ADDENDUM NO. 001

RE: Bristol Community Health Center, Phase I Renovations
For Southwest Virginia Community Health Systems
T&L Project No. 16493

DATE: March 30, 2023

SKETCH
ASK-01

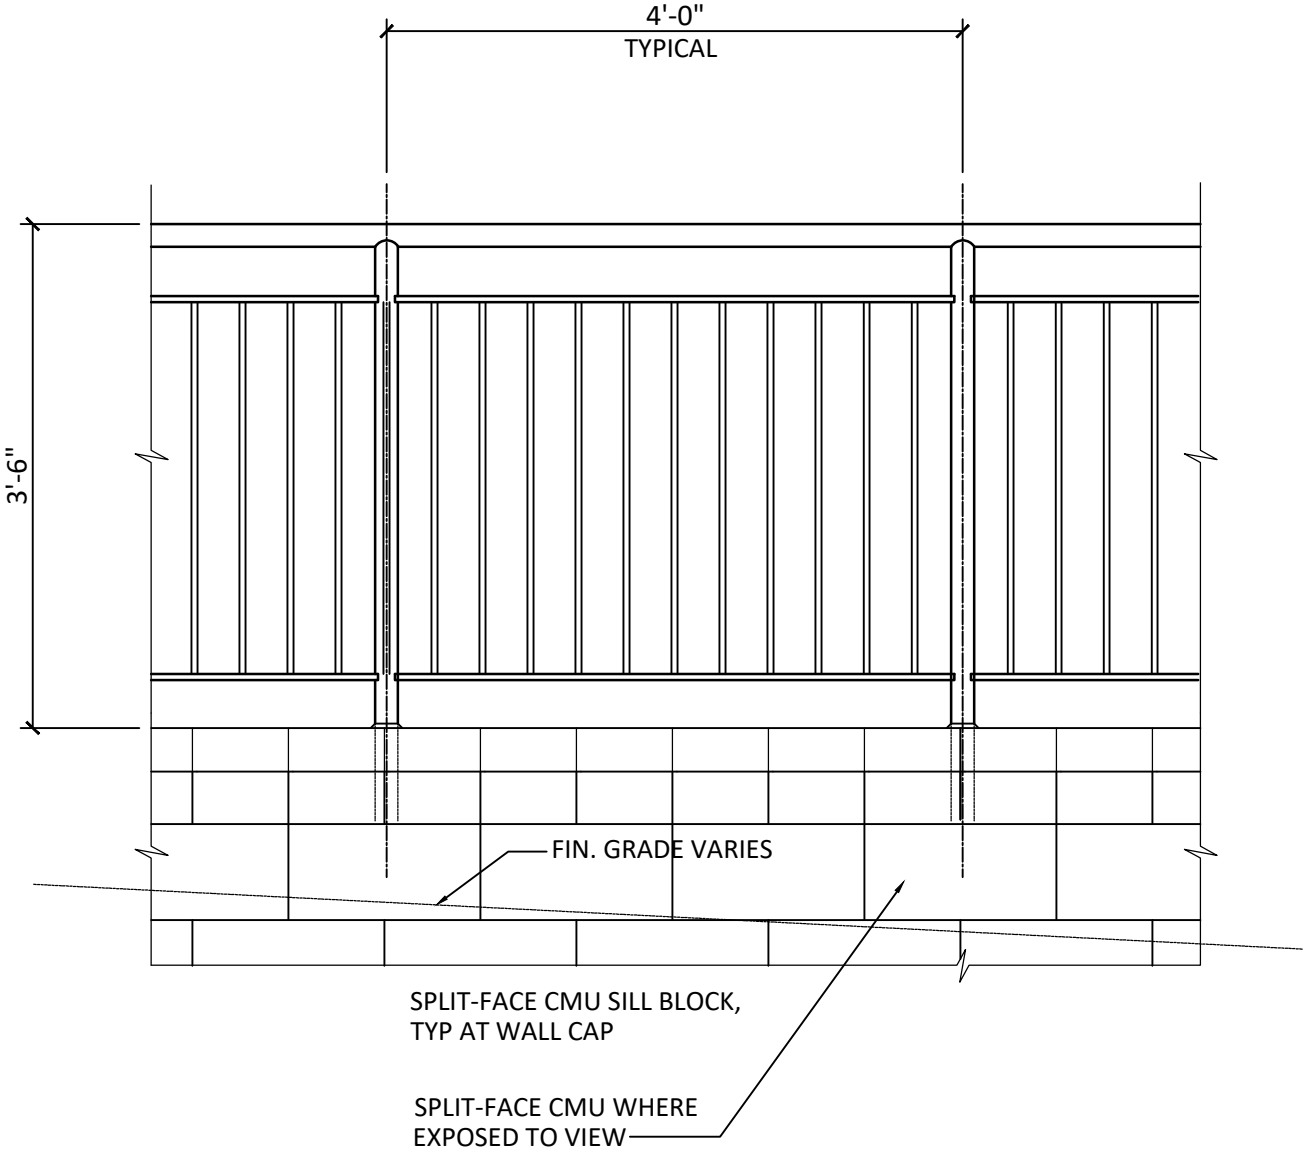
1. Refer to Sketches ASK-01 and ASK-02 for details of retaining wall cap and guardrail as indicated on Drawings A201 and S001.
2. Refer to Drawing A201. WC-1 references a wall cap and L-1 & L-2 refers to wall louvers as shown on Drawing M101. Refer to Sketch ASK-03 for an updated elevation of this area.

RETAINING WALL & GUARDRAIL SECTION

SKETCH ASK-05

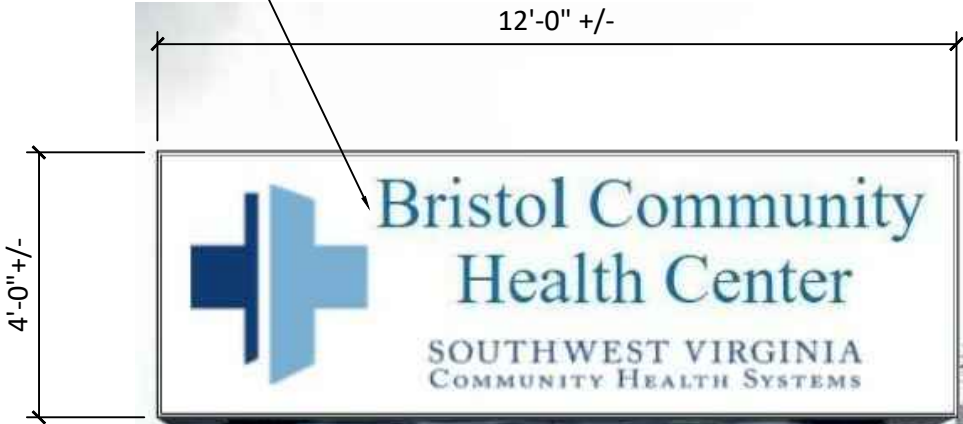
10. Provide locksets by one of three manufacturers listed in Section 08 7100, Par 2.8.A.
11. Refer to AS101 and ES101. The existing sign has its own service. The existing service and equipment can be maintained for the refurbished sign if it meets requirements for new sign. Refer to Sketch ASK-05 for additional requirements of site sign. Refer also to ASK-06 for additional requirements for refurbishment of existing building sign.

REMOVE EXISTING SIGN TOP ASSEMBLY COMPLETE AND REPLACE WITH NEW DOUBLE-SIDED LIGHTED SIGN HAVING POLYCARBONATE LENS. GRAPHIC AND TEXT TO BE APPROVED BY OWNER.

EXISTING FRAMED MESSAGE BOARD & TENANT SIGNAGE TO BE REMOVE COMPLETE

REPAINT EXISTING SIGN POSTS. COLOR IS TBD

MAINTAIN THE EXISTING SERVICE AND EQUIPMENT PROVIDED IT MEETS THE REQUIREMENTS OF THE NEW SIGN. IF NOT, PROVIDE NEW SERVICE.
